Conway Planning Commission
Staff Report

7:00pm • April 16, 2018 • 810 Parkway Avenue

CONWAY CITY PLANNING DEPARTMENT REVIEW MATHEWS MEADOWS PUD PRELIMINARY PLAT

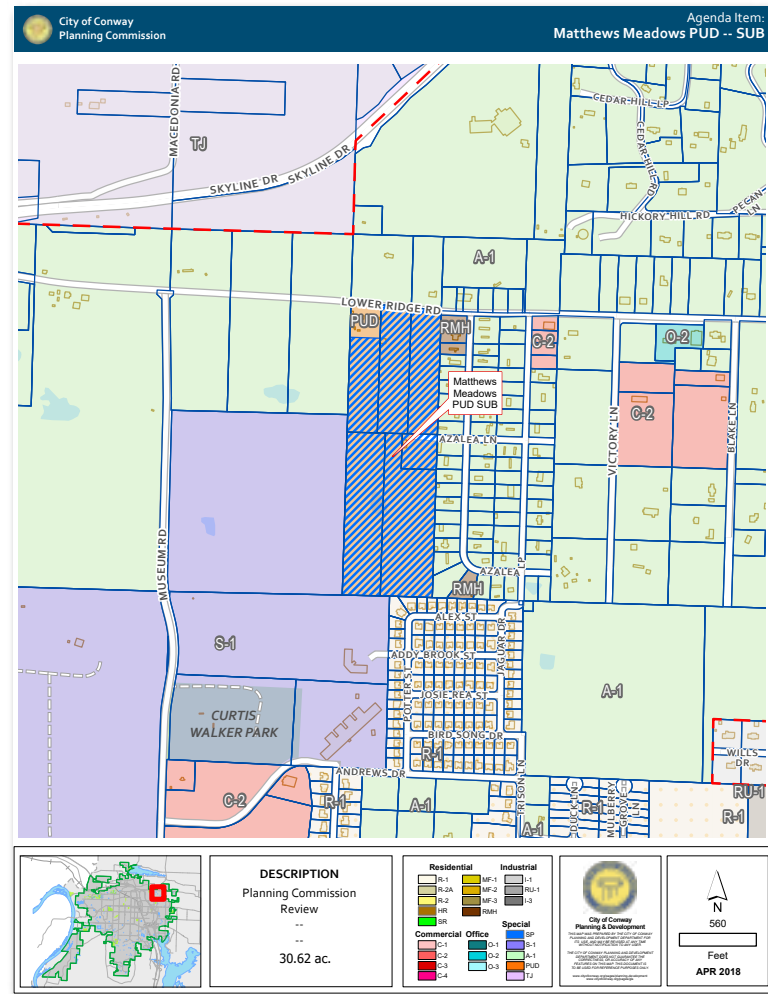
STAFF COMMENTS
Planning Commission action is required for items 19, 31, and 40.

- BASIC INFORMATION NEEDED ON THE PLAT**
- Proposed easements are needed and should be clearly identified.
 - A phasing plan outlining the boundaries for each phase and the location of all CAGIS monuments for the subdivision is needed. A minimum of two CAGIS monuments shall be placed in each subdivision or subdivision phase exceeding ten (10) acres.
 - The Certificate of Preliminary Plat Approval is needed. Add Jerry Rye, Chairman.

- The downstream drainage channel and drainage structures substantially impacted by the subdivision/replat shall be shown. Including Drainage Structures crossing Addy Brook Ln.
- Existing streets, buildings, water courses, railroads, culverts, utilities and easement on and adjacent to the tract are needed.
- A draft of any Bill of Assurance proposed for the subdivision generally describing proposed covenants, restrictions and conditions applicable to the property included in the submitted plat is needed.

19. The designers of residential streets are encouraged to lay them out to slow the use by through traffic. ***The Planning Commission may require that traffic calming techniques be employed. Planning Commission does / does not require traffic calming techniques be implemented.***

31. Blocks over 1000 feet in length may require a public crosswalk within a dedicated easement of not less than 15 feet in width including a paved crosswalk not less than five feet in width to provide pedestrian circulation. ***Planning Commission Does / Does Not require public crosswalks in the 1,010' long blocks.***

40. Sidewalks are required along both sides of all streets within all zoning districts within Conway city limits and within the Conway Territorial Jurisdiction. Sidewalk notes and requirements as directed by the Planning Department are needed on the plat. ***A variance has been received requesting sidewalks along one side of roads only. Planning Commission Approves / Does not Approve this request, or this condition must be corrected. If approved, An in-lieu fee equal to \$15 per linear feet of each lot's street frontage will be required for those lots not constructing a sidewalk.***

CONWAY PROFESSIONAL PLAZA

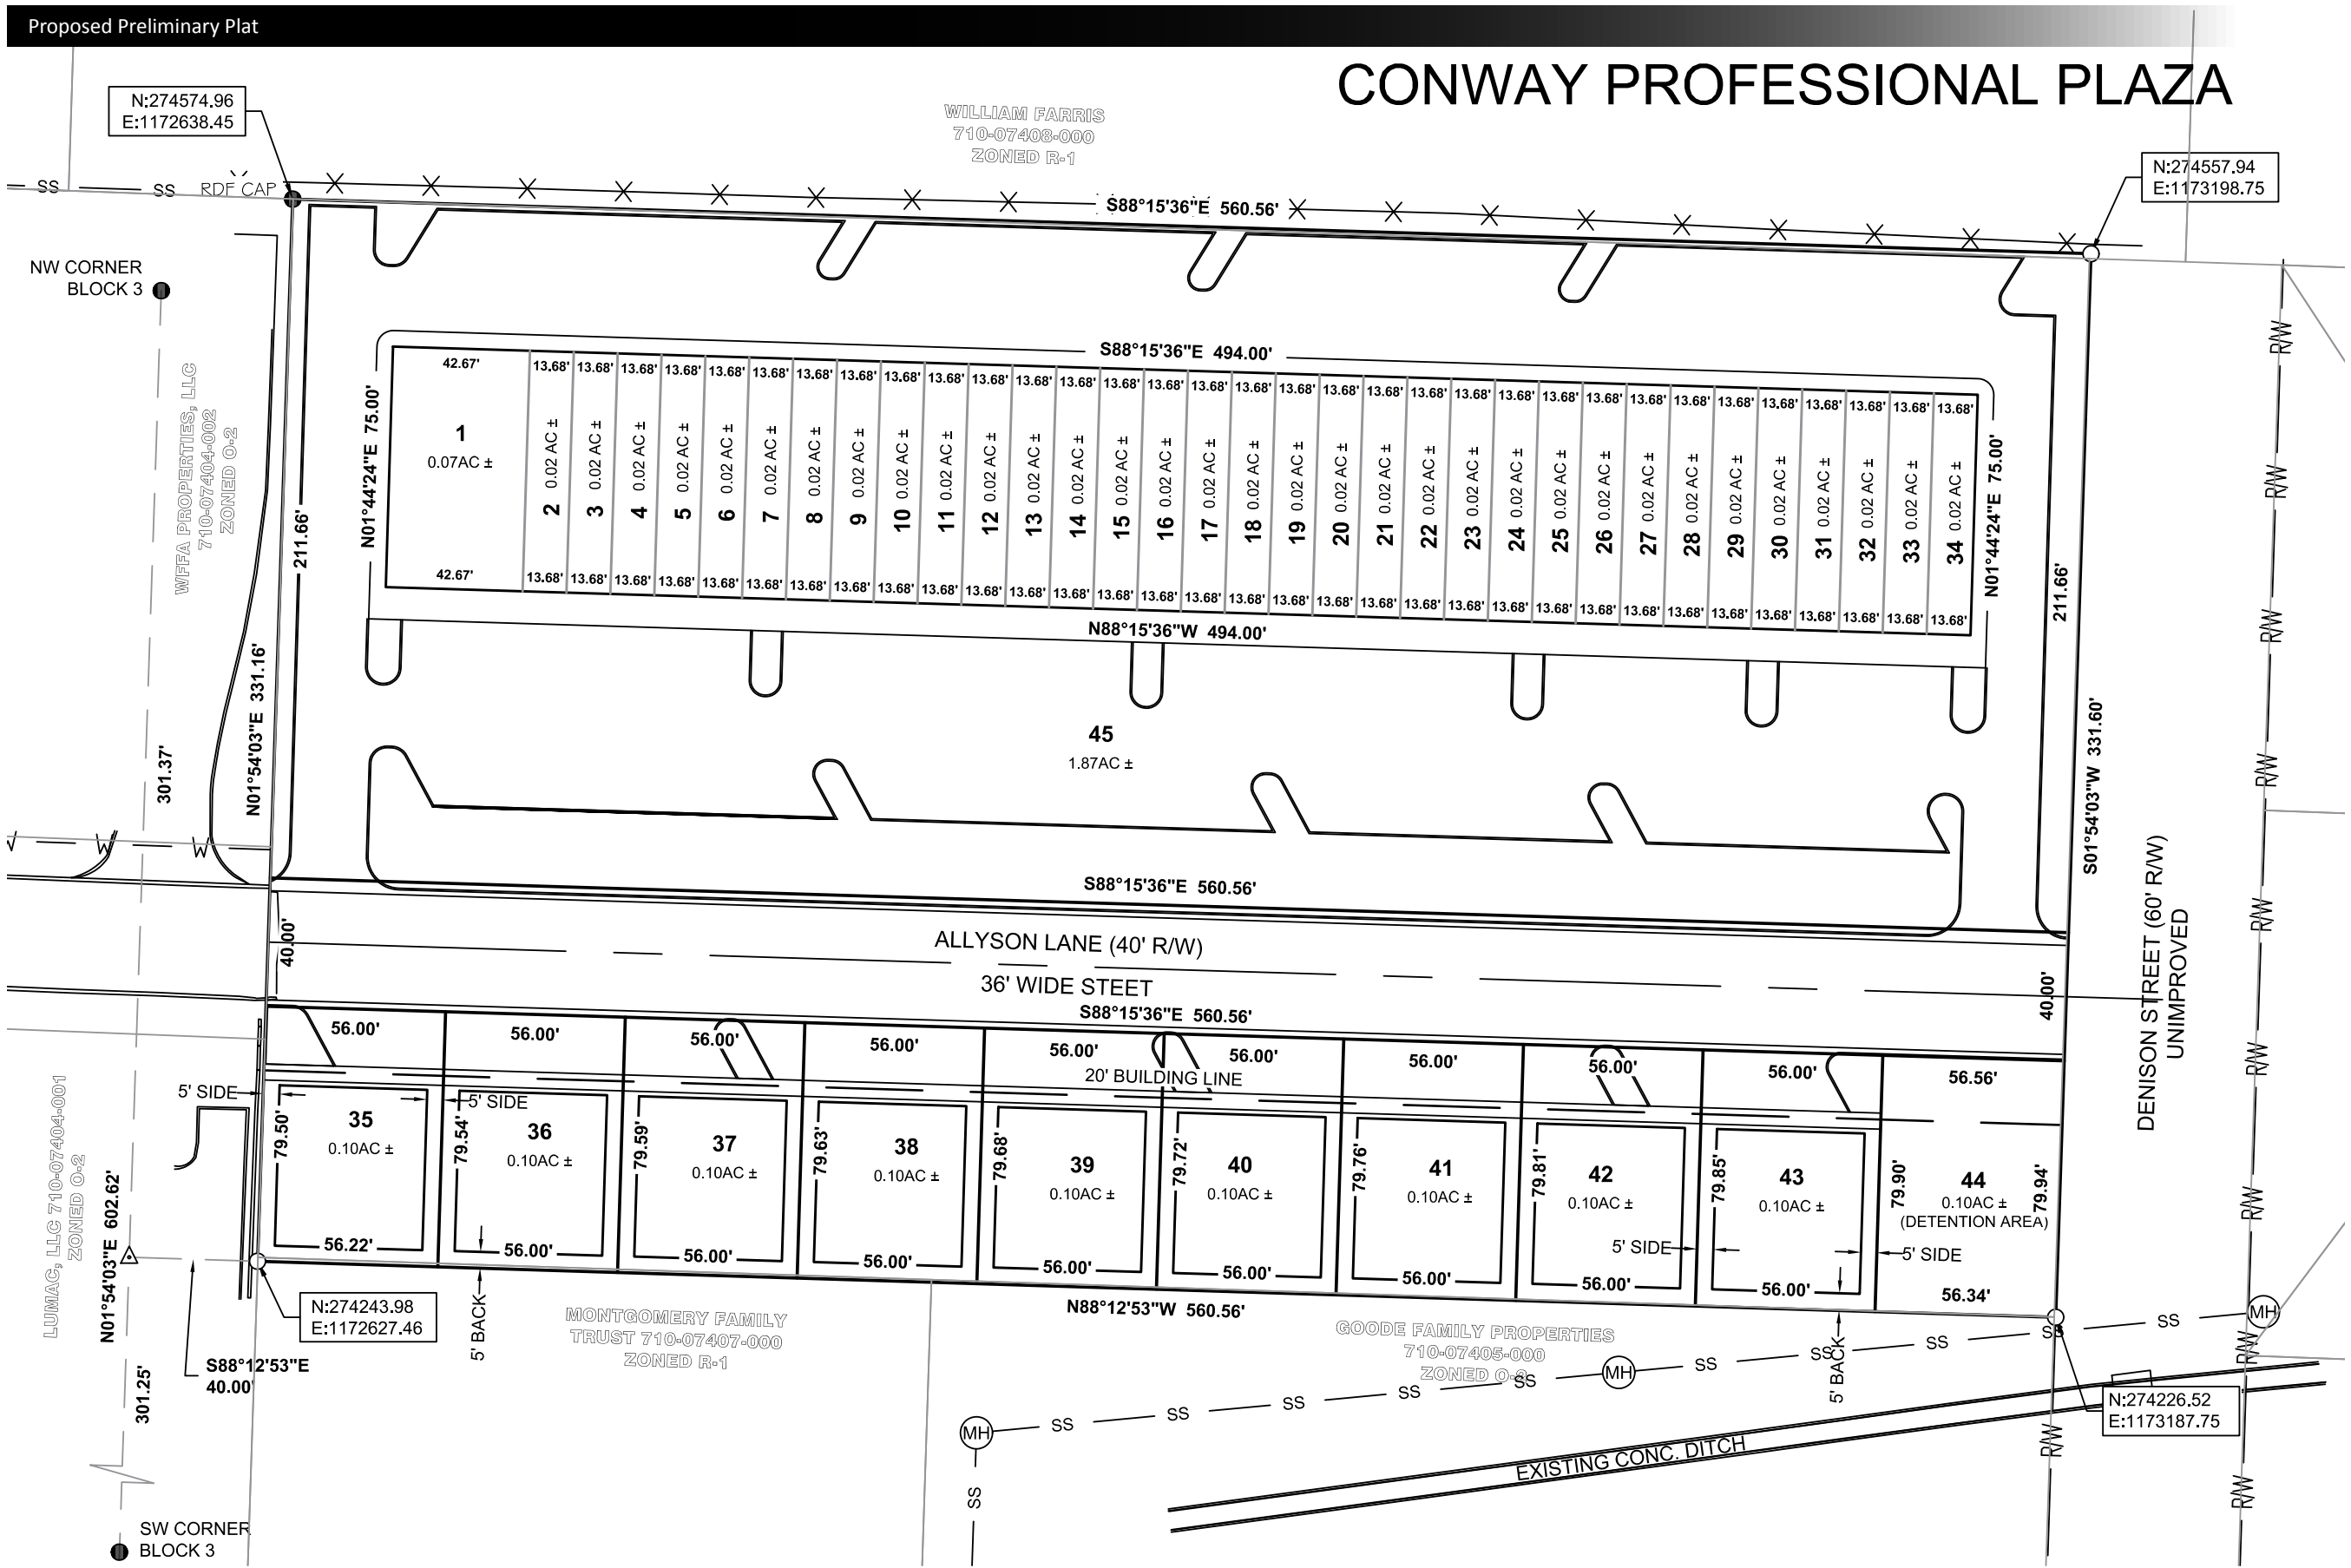
1. A vicinity map showing the location and *corrected* acreage of the subdivision/replat must be shown.
2. A legal description of the property with exact boundary lines, bearings and distances is needed.
3. If any portion of the land being subdivided is subject to flooding, the limit of such flooding shall be noted and the appropriate 100 year floodplain and/or floodway shall be identified.
4. The layout of all proposed sidewalk systems are needed, along with relevant dimensions and bearings.
5. Proposed easements are needed.

13. State Fire Code 503.0.5 states that dead-end fire apparatus access roads in excess of 150 feet in length shall be provided with an approved area for turning around fire apparatus. Anything other than the following cul-de-sac requirement must be approved by the Conway Fire Marshall. *Fire Marshall approved single access Allyson Lane is acceptable with no required improvement to Unimproved Denison Street.*
14. Where residential streets intersect other residential, collector or arterial streets, the curb radii at the intersection shall not be less than 28 feet.

Proposed Phase II Preliminary Plat

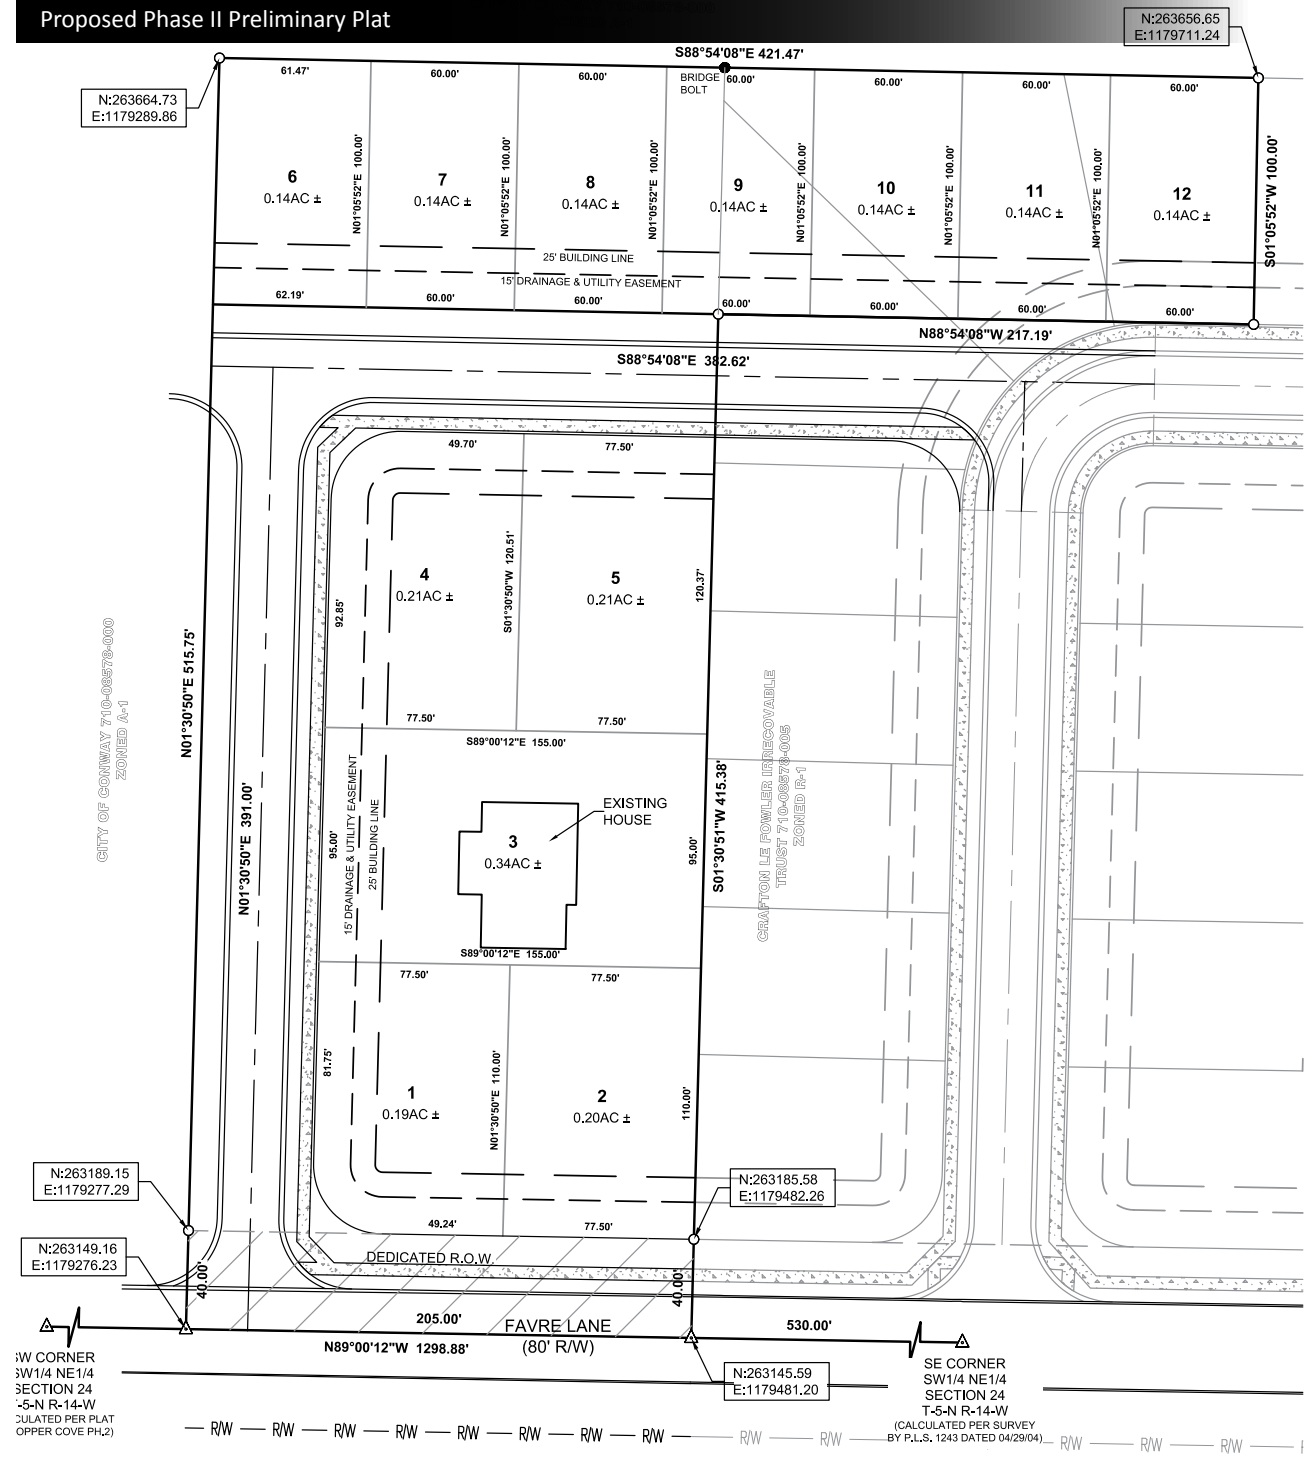
1. The layout of all proposed sidewalk systems are needed, along with relevant dimensions and bearings.
2. Street names that are not similar to existing street names are needed for all proposed streets.
3. Proposed easements are needed.
4. Land to be reserved or dedicated for public use must be shown. *Dedicated ROW needs to be labeled.*
5. For subdivisions of ten (10) acres or less in size, no new CAGIS monumentation is required. However, these smaller subdivisions must all be tied to CAGIS monumentation.
6. The Certificate of Preliminary Plat Approval is needed. *Change Chairman name to Jerry Rye.*

- 12. Minimum lot width on Collector and Above – In order to reduce potential traffic conflict points caused by lots with less than 100 feet of street frontage with access to collectors, minor arterials, and major arterials, the **Planning Commission and/or the Director of Planning may require the grouping or sharing of driveways. Driveway access easements will be shown on the plat. (O-11-98) Planning Commission Requires / Does not Require the driveway for lot 1 to load from the proposed street, and lot 2 driveway to load from Favre Lane.**

Proposed Replat

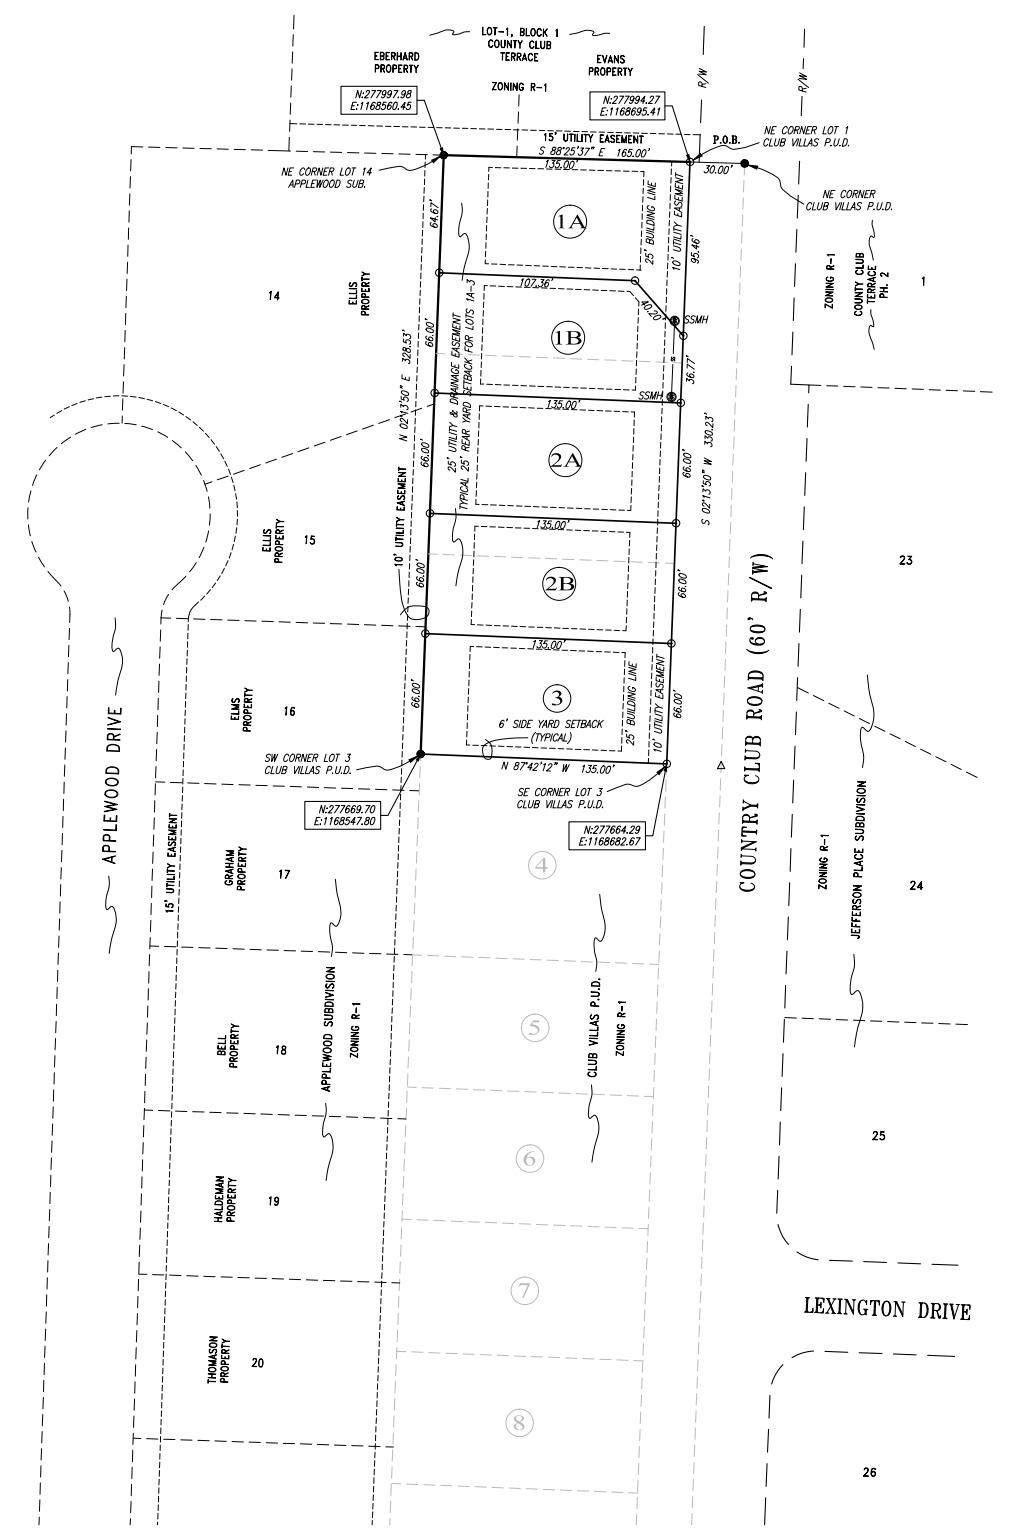
1. If any portion of the land being subdivided is subject to flooding, the limit of such flooding shall be noted and the appropriate 100 year floodplain and/or floodway shall be identified.
2. The layout of all proposed sidewalk systems are needed, along with relevant dimensions and bearings.
3. Any proposed open space must be shown.
4. The source of water supply must be shown.
5. The method of disposal of waste water must be shown.
6. For subdivisions of ten (10) acres or less in size, no new CAGIS monumentation is required. However, these smaller subdivisions must all be tied to CAGIS monumentation. *CAGIS monument number is needed.*
7. The Certificate of Preliminary Plat Approval is needed.

- 11. Minimum lot width must conform with the requirements of the Zoning Ordinance. **A variance request has been received for a reduced front lot width for lot 1B to accommodate utility needs. The Planning Commission Approves / Does not Approve this request, or this condition must be corrected.**
